## STOP USE AND INSPECTION NOTICE

#### Specific 3M™ DBI-SALA® Nano-Lok™ Self Retracting Lifeline with Anchor Hook

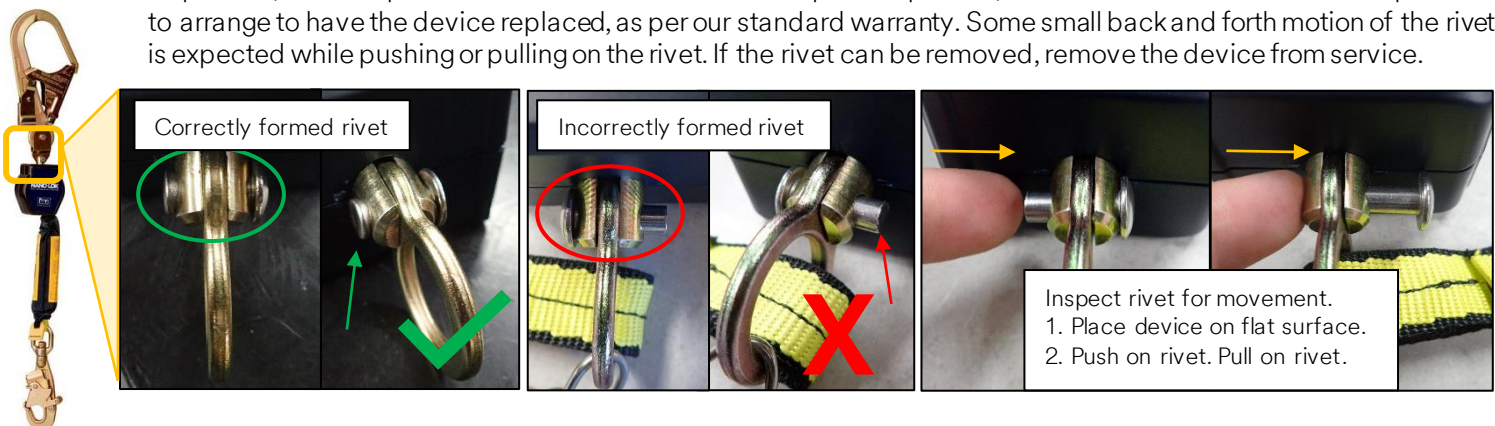
Step 2: Locate the label on the device (see photograph to right) to determine the model number and if it was manufactured between September 1, 2020 and August 31, 2021. If the device is an impacted model and was manufactured during the affected date range, please continue to Step 3.
